PRELIMINARY 27 QUINCY ST
Chevy Chase Village Historic District

From: Alexandra Kolakowski [akolakowski@kbarchitecture.com]
Sent: Friday, December 15, 2006 10:28 AM
To: Oaks, Michele
Cc: jkatinas@kbarchitecture.com
Subject: 27 Quincy Bay Modification

HISTORIC PRESERVATION COMMISSION STAFF REPORT

Landau Residence Addition
Caroline and Christopher Landau
27 Quincy Street
Chevy Chase Village
Chevy Chase, MD 20815

PROPOSED
BAY MODIFICATION

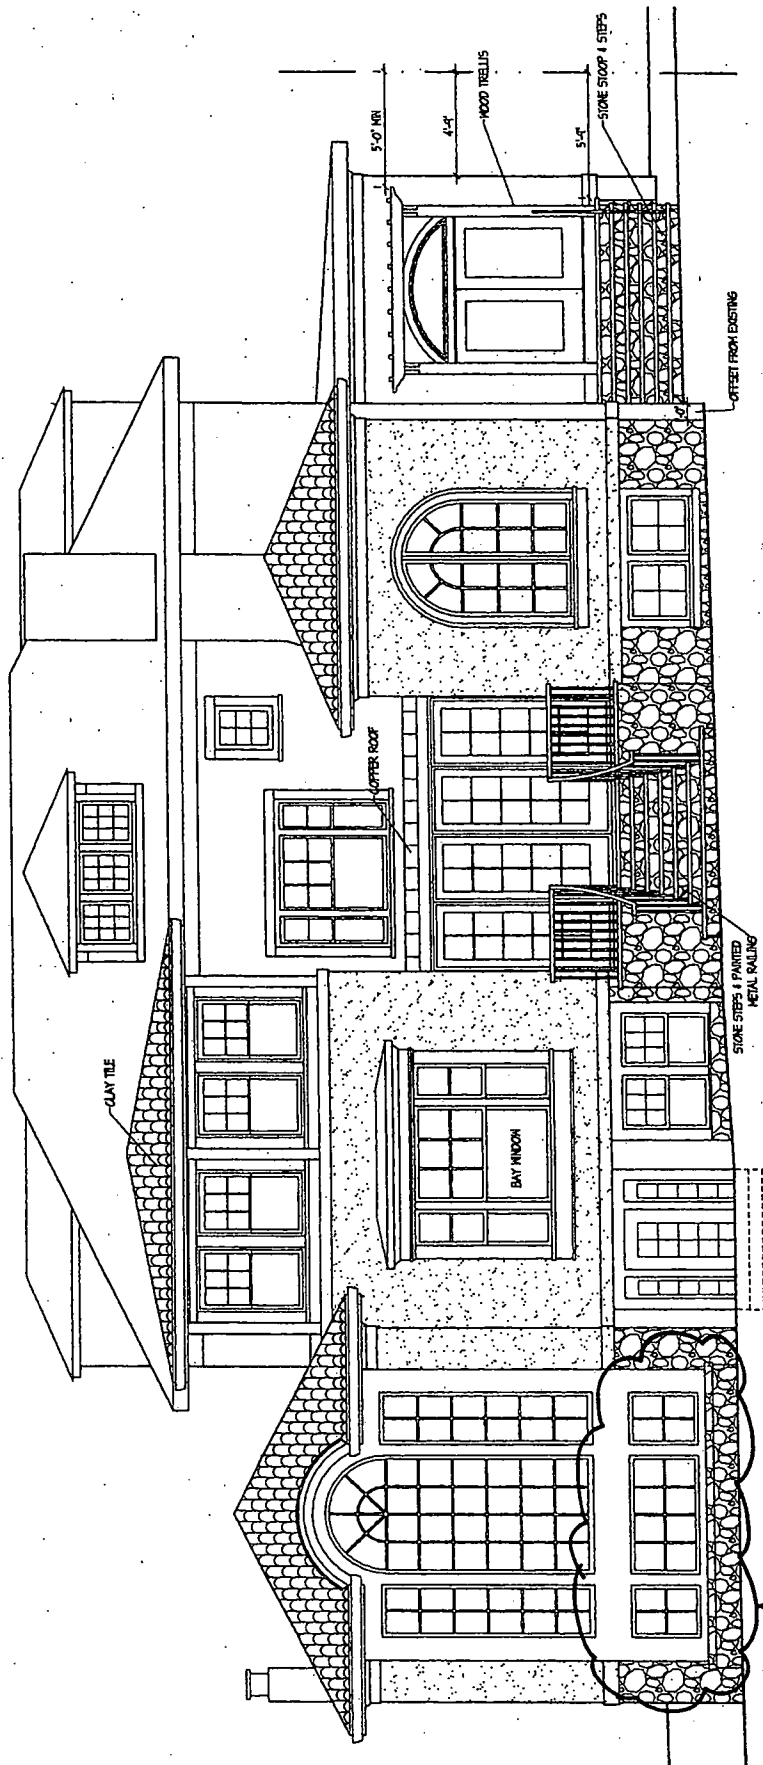
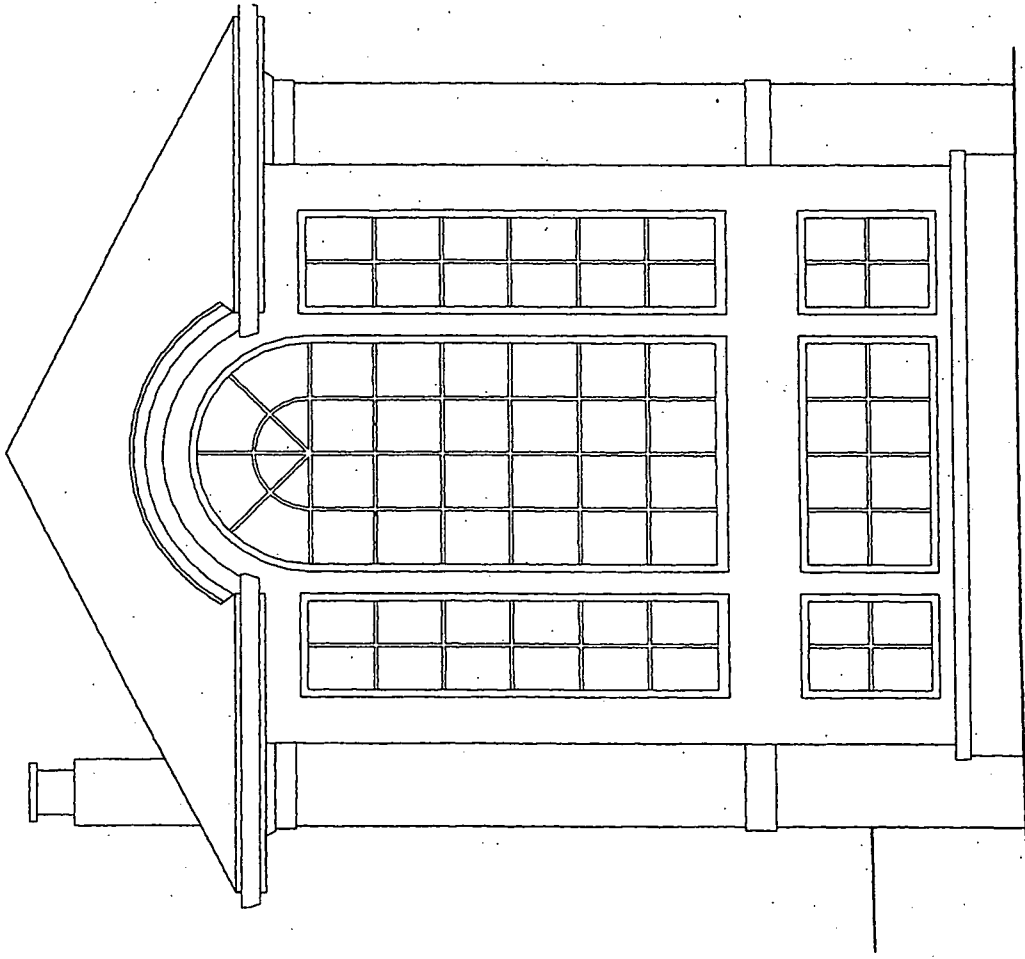
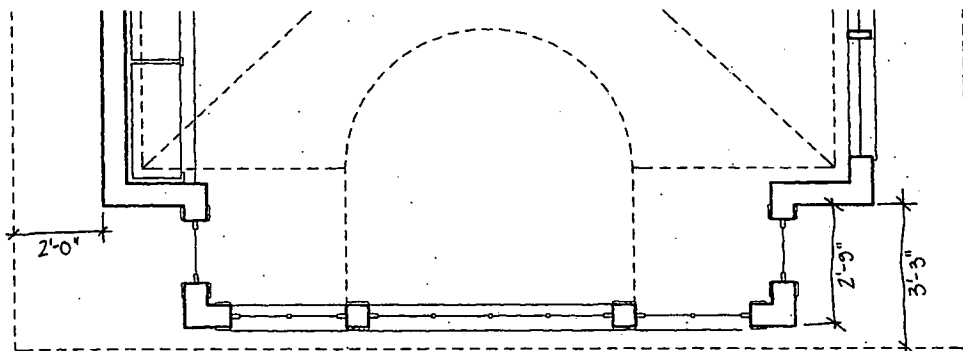
We have finalized a plan for the bay in the family room addition for the Landau residence at 27 Quincy Street. The modification deepens the bay shown in the current scheme and continues the projection in the basement bedroom below. We hope for your recommendation on how to proceed, seeing as we currently have an alteration in for historic approval, and this one is in addition to that change. I have attached a pdf file including the current scheme as well as the final scheme I described above. If there is more we can do, please let us know. Thank you.
